SERVICE BULLETIN

APPLICABILITY: 2015-16MY and Early 2017MY Legacy and Outback

NUMBER: 07-114-16R

SUBJECT: Power Seat Memory Feature Operating Concerns

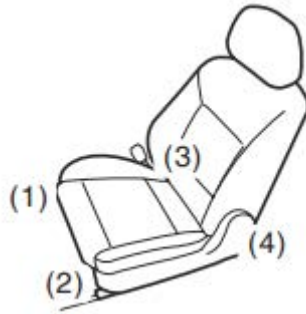
IMPORTANT: The part number and location of the new seat memory control module are unchanged. For this reason, the color of the part number label affixed to the module must be confirmed to differentiate between the old and new parts as shown in the illustration below. The old module label is Blue (inset) while the new version is Brown.

- When replacing the module, torque the 2 retaining nuts to 5.9 Nm (4.4 ft. lbs.).
- When reinstalling the seat assembly, the 4 retaining bolts must be hand-tightened first then final torqued to 53 Nm (39.1 ft. lbs.) using the sequence shown in the illustration below.
